**Step-1 Report on**  
**Cambridgeport Traffic**

with Special Attention to Development  
of the Polaroid Site and Bread & Circus

prepared by: Stephen H. Kaiser  
191 Hamilton Street  
Cambridge, Mass. 02139

*December 10, 1997*

**FIGURE 3**  
**Traffic Signal Timing at Six Primary Arterial Intersections**  
**Existing 1997 PM Peak**

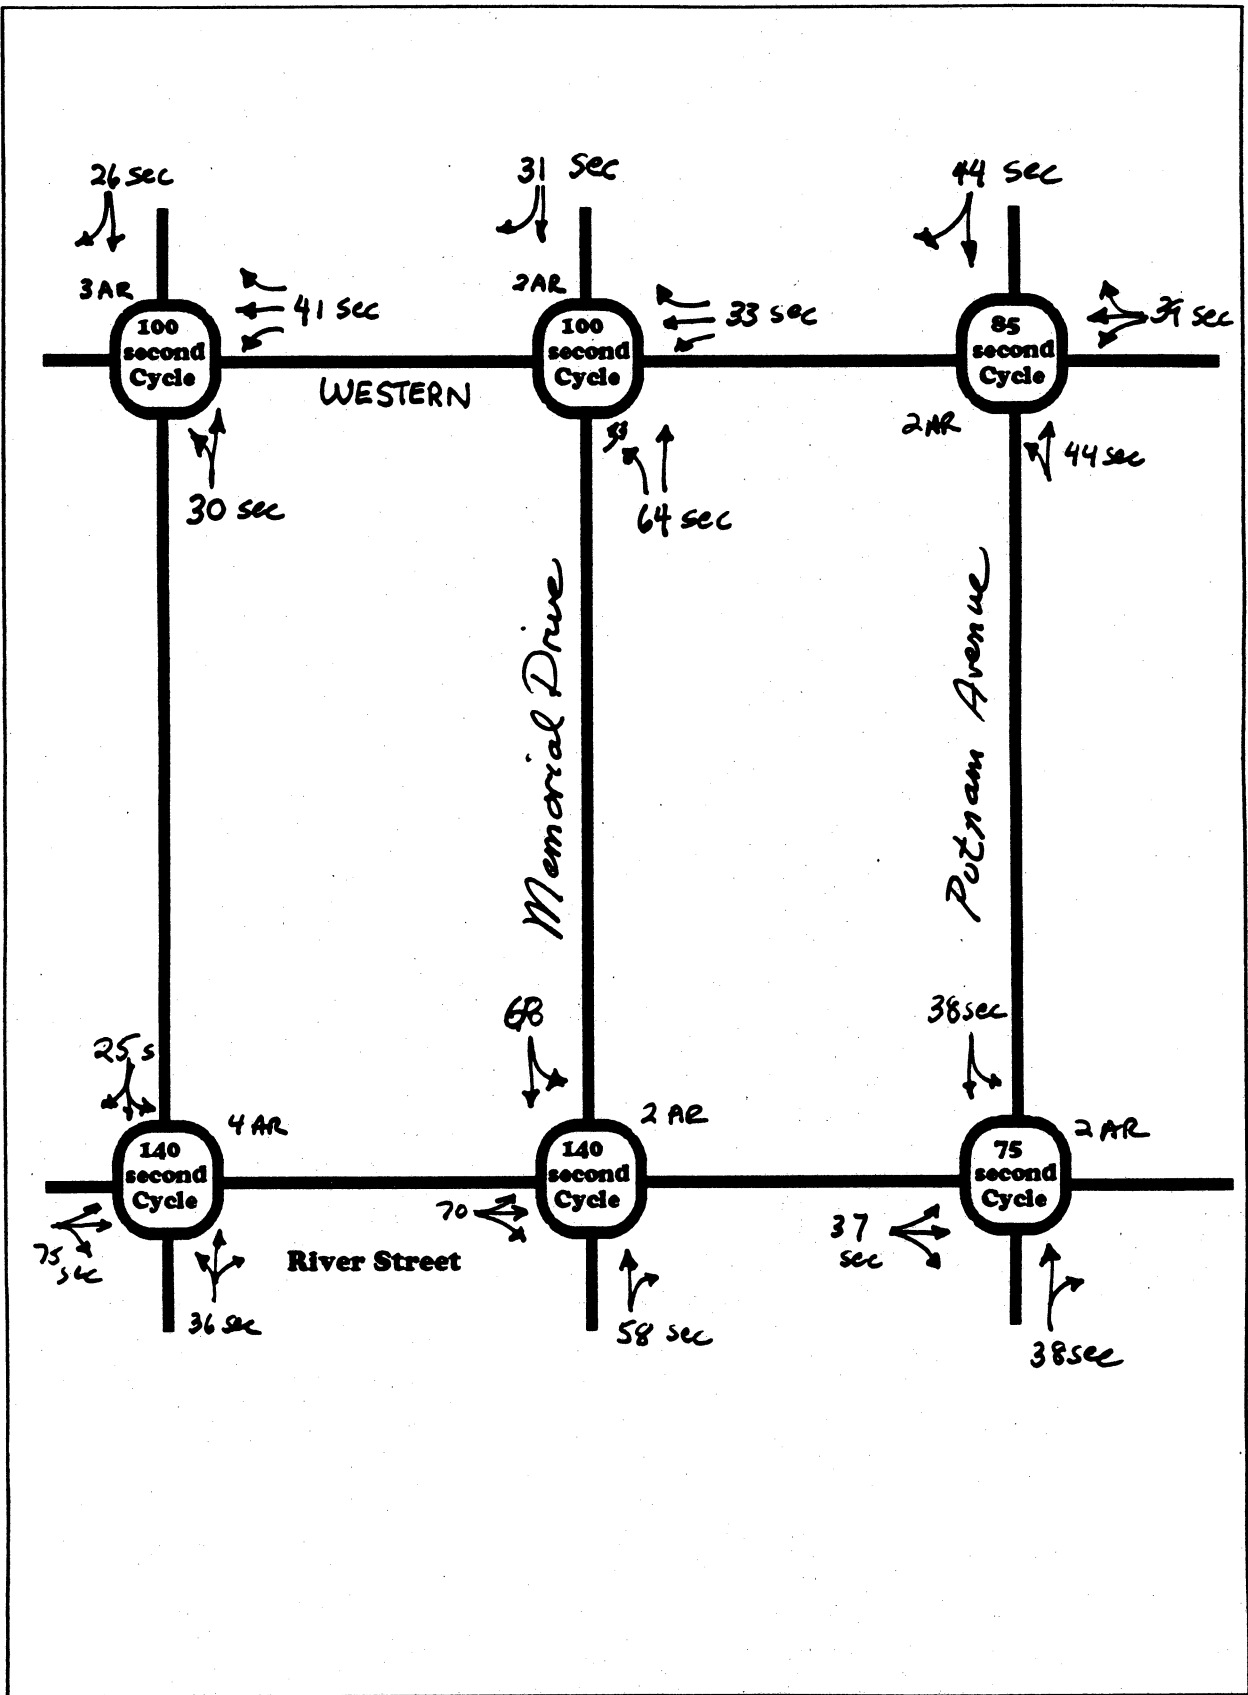
The six key signalized intersections form a ladder-like grid in a 2-by-3 array, as shown in Figure 3. By observation, of seven possible links in the grid, five can generate a queue which blocks a nearby signal. Of these seven links which could be subject to coordinated signal timing, there are only two which are now coordinated for signal timing, and this has been achieved only within the past two years. Pedestrian actuated buttons occur at three of the six, as do WALK lights. It is worth noting that despite the existence of central computer control in Cambridge, the Putnam Avenue signals at River and Western Avenue are not coordinated, nor do they have any relation to the operation of signals on Memorial Drive, which are under the control of the MDC.

Figure 3 represents field observations of afternoon peak hour signal timing, with both cycle times shown, total All-Red Clear, and the combined Green-and-Yellow times for each approach. The importance of field measurements cannot be overemphasized, simply because signal timings designated by headquarters may be quite different from those actually operating in the field -- especially if there is a power outage which throws an internal clock out of proper timing. There appears to be variable cycle timing on Putnam Avenue when the pedestrian phase is called, and the two Soldiers Field Road intersections show evidence of some variability in signal timing due to detection, but the desired purpose and effectiveness are unclear. For peak hour purposes, signal actuation generally proves to be ineffective, so that constant signal timing can be used as an assumption for capacity analysis, as was done in the Polaroid and Bred & Circus reports.

In summary, the three reports use the following signal timing :

CNI -----	Bread & Circus -----	Polaroid -----
1. Putnam Avenue & Magazine St.	60 s Semi-Act	60 Actuated	(Not studied)
2. Putnam Avenue & River Street	75 s Pretimed plus peds	75 sec Actuated (no peds)	90 sec Semi-Act (17 sec Peds)
3. Putnam Ave. & Western Ave.	85 s Pretimed plus peds	90 sec Actuated (no peds)	90 sec Semi-Act (17 sec Peds)
4. Memorial Dr. and River Street	140 s Pretimed	105 sec Pretimed	100 sec Semi-Act
5. Memorial Dr. and Western Ave.	100 s Pretimed	(Not studied)	100 sec Pretimed
6. Soldiers Fld Rd & Turnpike	140 s Pretimed	(Not studied)	(Not studied)
7. Soldiers Fld Rd & Western Ave.	100 s Actuated?	(Not studied)	(Not studied)

As is apparent, the various traffic engineers have not been able to attain agreement on the existing signal timing.

**FIGURE 12**

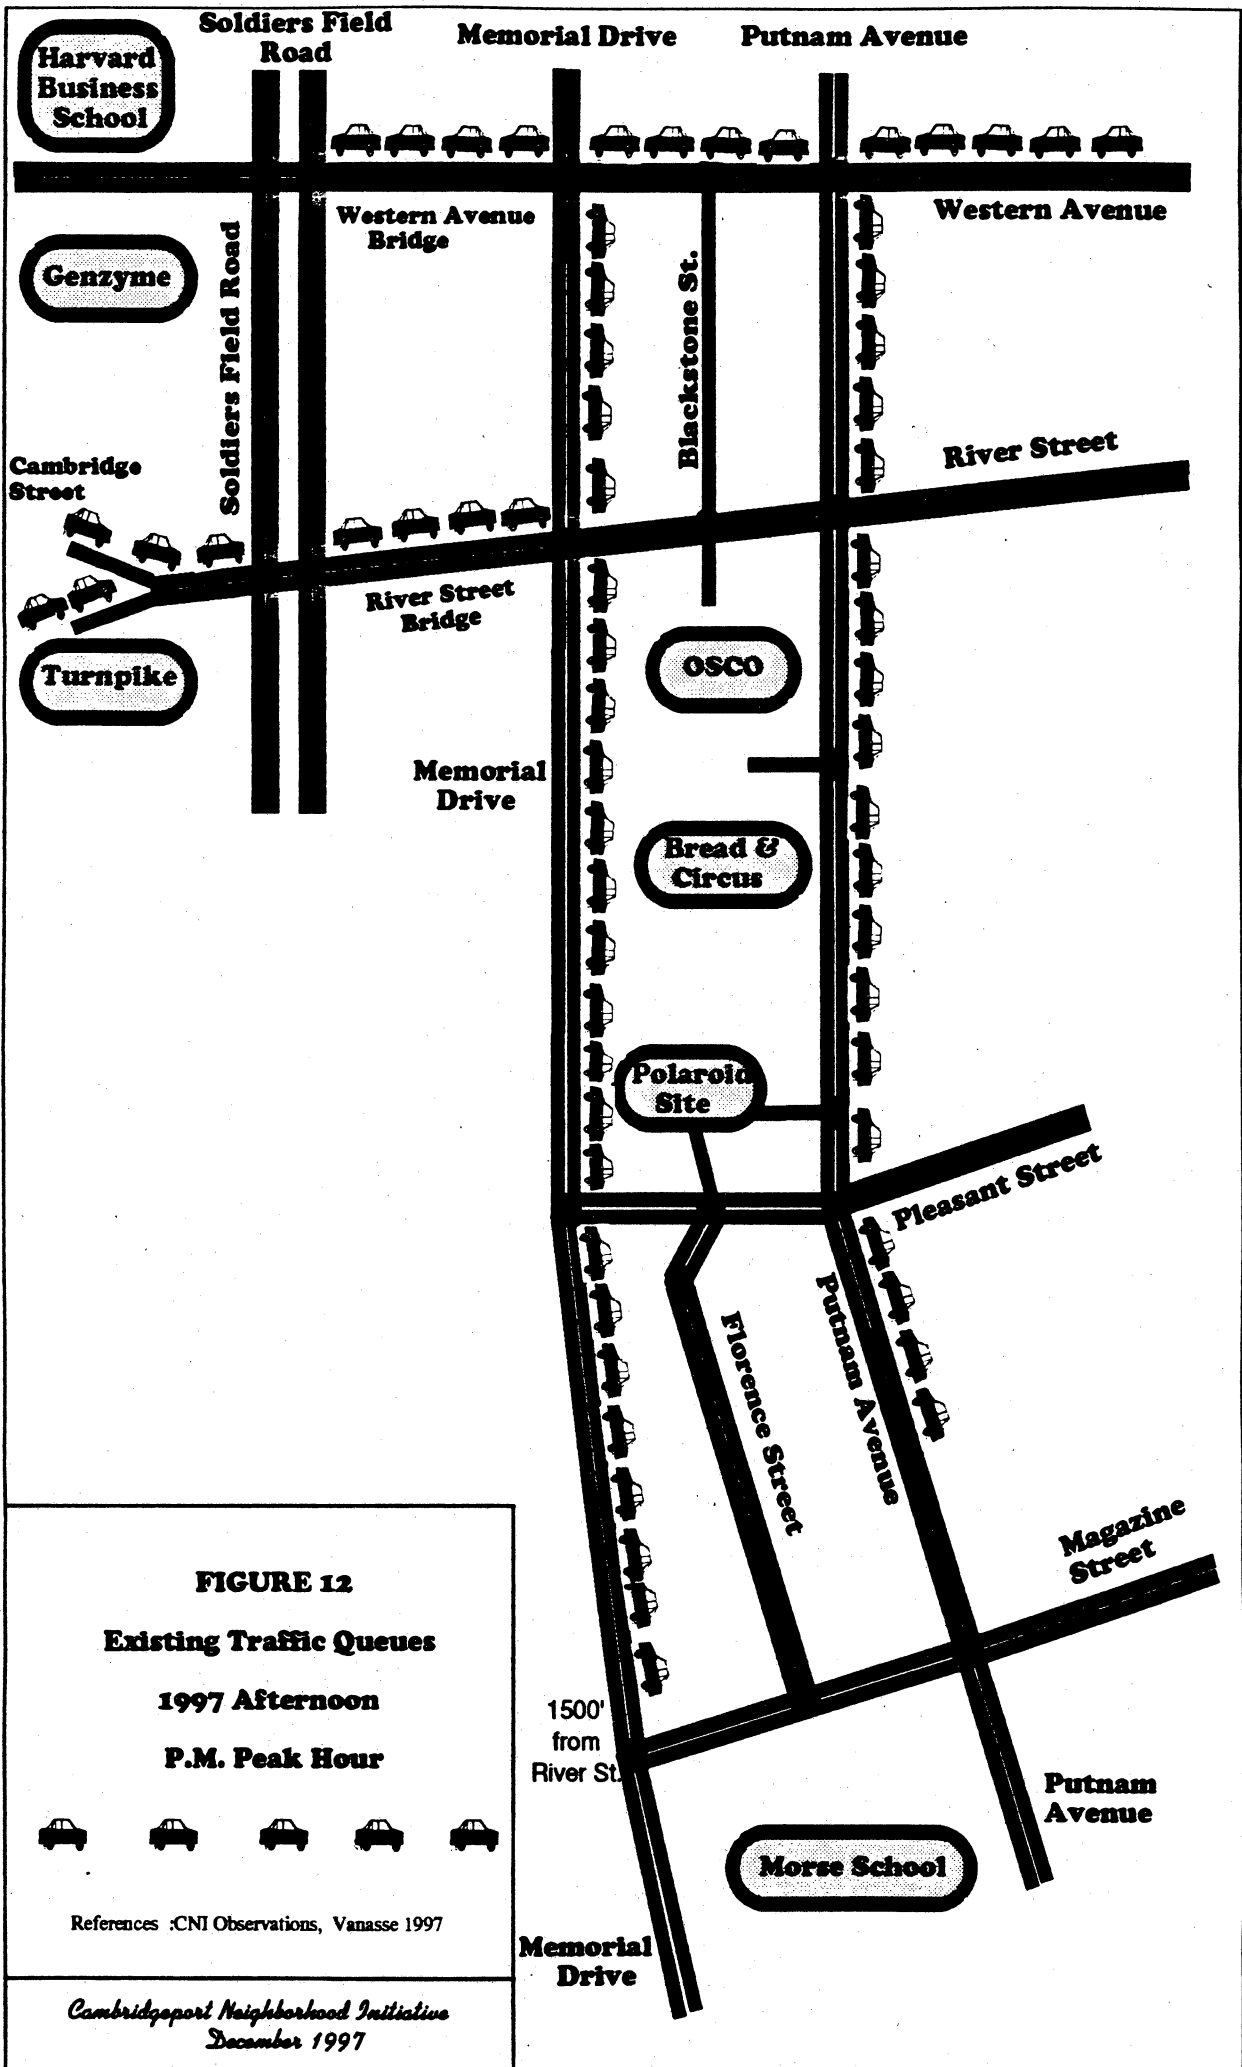
The typical queue lengths noted in the afternoon peak hour are shown graphically in Figure 12, with the most prominent queue being on Memorial Drive, but queues are also significant on Western Avenue and Putnam Avenue. Another queue which affects flows from the Boston side occurs on the River Street bridge.

By observation, we can see how the traffic queues are spawned at one location and almost like dominos create queuing conditions elsewhere. As we can see from Figure 12, queues from 5 intersections can grow to interfere with other ones. These are :

- ∞ **Western Avenue : from Soldiers Field Road across the bridge and into the Memorial Drive intersection**
- ∞ **Western Avenue : from Memorial Drive back and into the Putnam Avenue intersection**
- ∞ **Putnam Avenue : From Western Avenue into River Street**
- ∞ **Memorial Drive : From Western Avenue into River street**
- ∞ **River Street : From Memorial Drive into Soldiers Field Road and onto the Turnpike exit**
